ORIGINATION FORM

Proposed Revisions to a Standard Plans Index
(Please provide all information – Incomplete forms will be returned)

Index Number: **700-101**
Sheet Number (s): 1
Index Title: Typical Sections for Placement of Single and Multi-Column Signs

Changed lateral offsets.

CASE VI

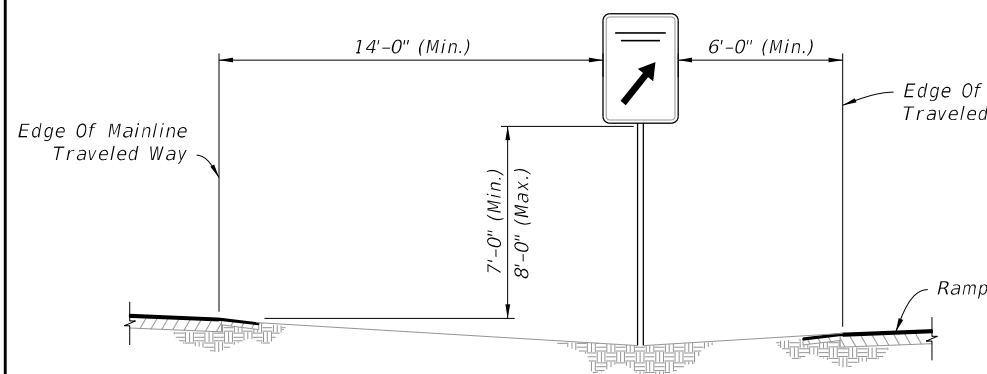
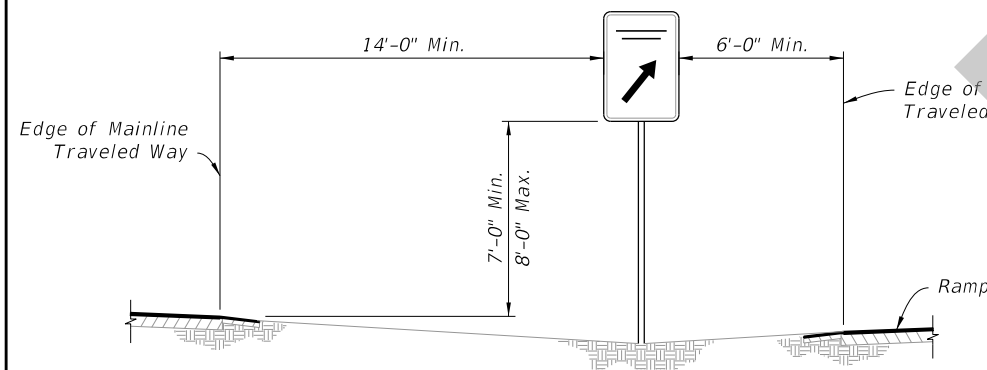
CHANGED: Lateral Offsets

Use on Roadways With Signs Behind Guardrail
